Application for Works Approval

Works Approval Number W6949/2024/1

Premises Marymia Gold Project – K2 Project
Mining Tenements M52/183 and M52/233
MEEKATHARRA WA 6642

Date of report 19 November 2024 (FINAL)

Figure 2: Infrastructure Locations

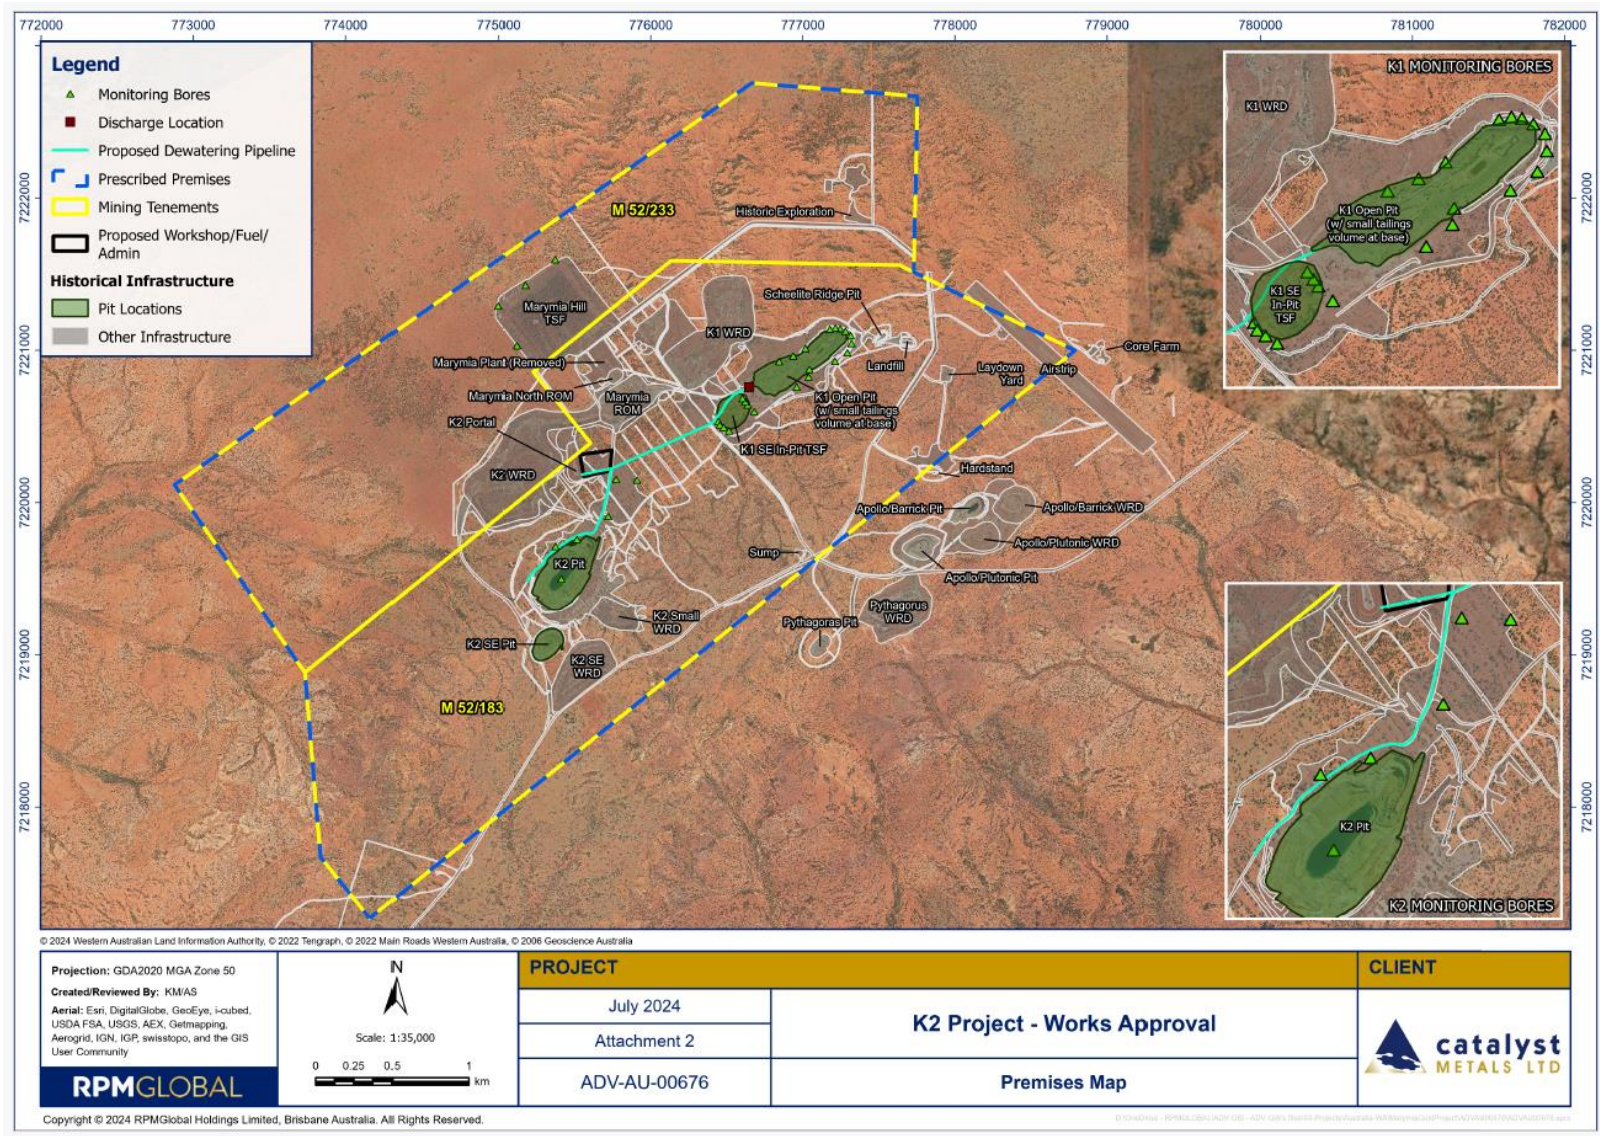
7, Table 3 Emissions and discharges limits during environmental commissioning	Request that the limit for mine water discharge during commissioning be changed to '80,000 tonnes' (commissioning period runs for up to four weeks).	Updated as requested
16, Table 6 Emissions and discharges limits during time limited operations	Request that the limit for mine water discharge during time-limited operations changed to align with the requested throughput value. This should be amended to the 500,00kL (time limited operations) to allow for the dewatering to occur as quickly as possible. [Note that 250ML over 180 days = 16L/s which may not be sufficient to dewater the infrastructure]; or, amended to 466,560 tonnes for time limited operations (based on a pumping rate of 30L/s).	Updated as requested
Schedule 2: Monitoring, Table 9	Requested deletion of text – refer to strikethrough text below: K1 Pit – dewatering discharge to pit As depicted in Figure 2	Wording retained to specify where K1 Pit discharge is (graphically)

Figure 3: K1 Groundwater Monitoring Bore Locations (Note K2 Pit Monitoring Bore is shown in Figure 2)

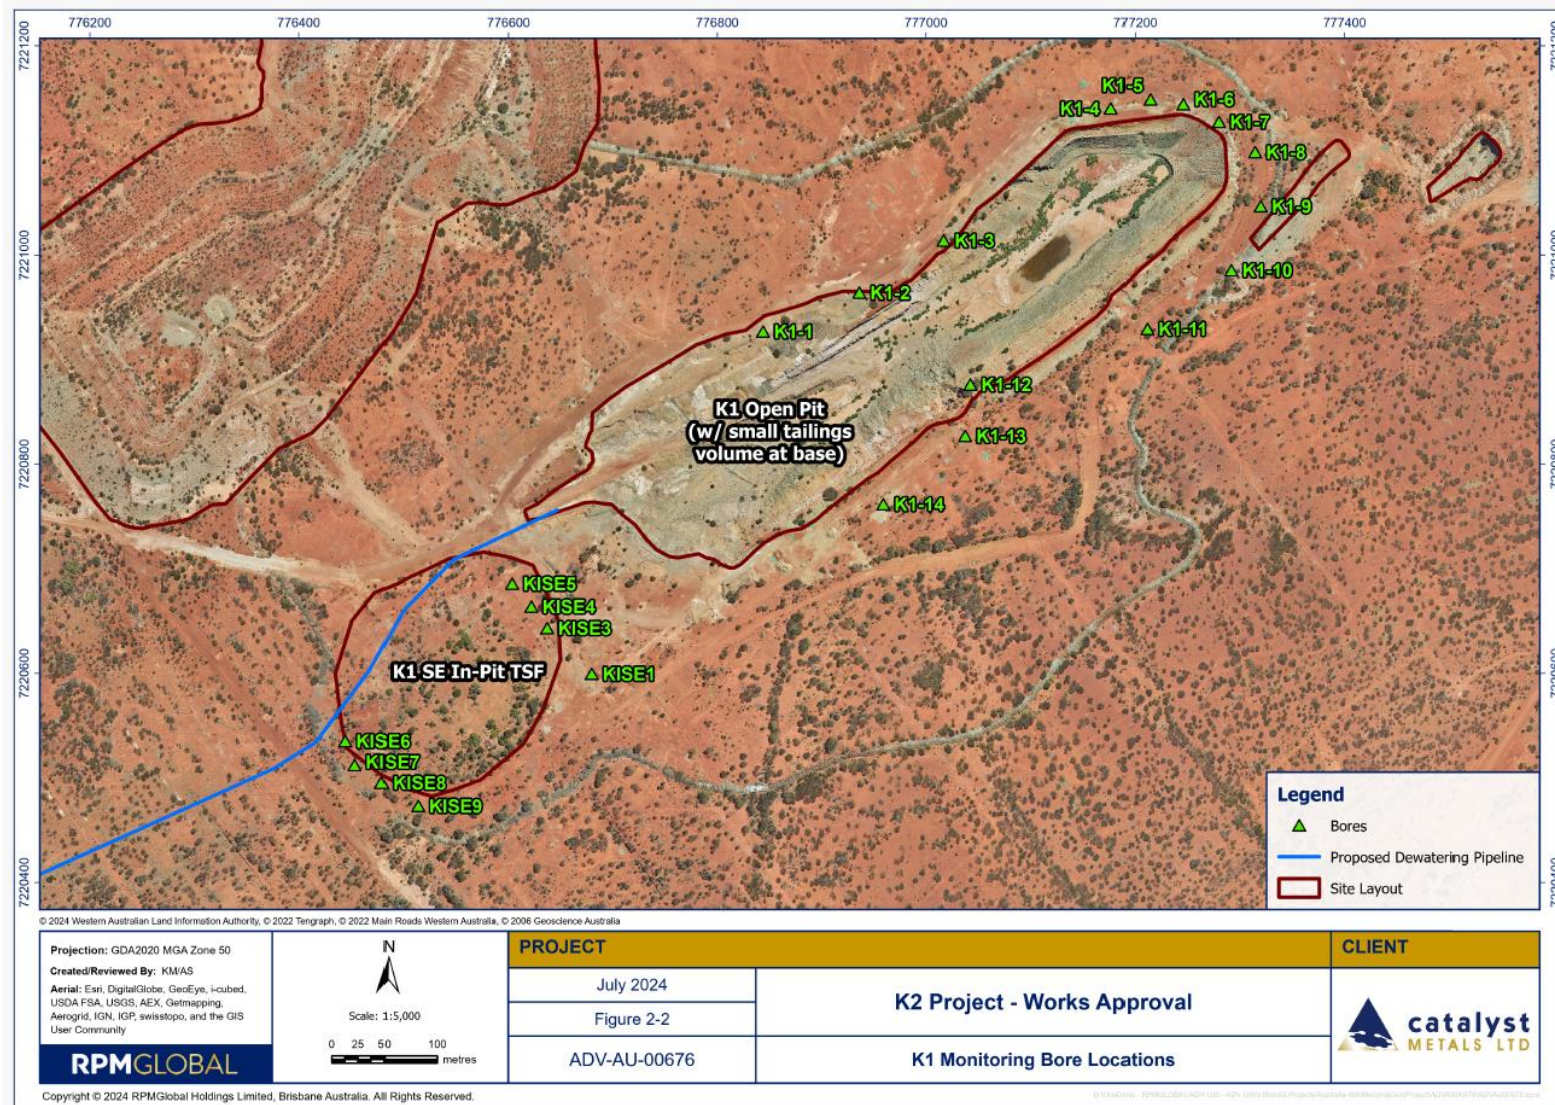
Supporting document	Dampier has indicated that it will monitor groundwater level and quality once prior to construction and quarterly during operation. Monitoring groundwater level and quality once does not seem sufficient to provide adequate understanding on the baseline data for water quality. Further, Dampier has not indicated whether it will enact management measures in the event a groundwater issue is noted.	The Applicant commenced SWL and field sampling in K1 – commenced in June 2024. The SWL in this area is approx. 38-44m deep. Field sampling reveals 7-7.4 pH, TDS 650-2000. 10 of the 14 monitoring holes around K1 are being assessed for SWL and 4 are being assessed for Field Sampling.
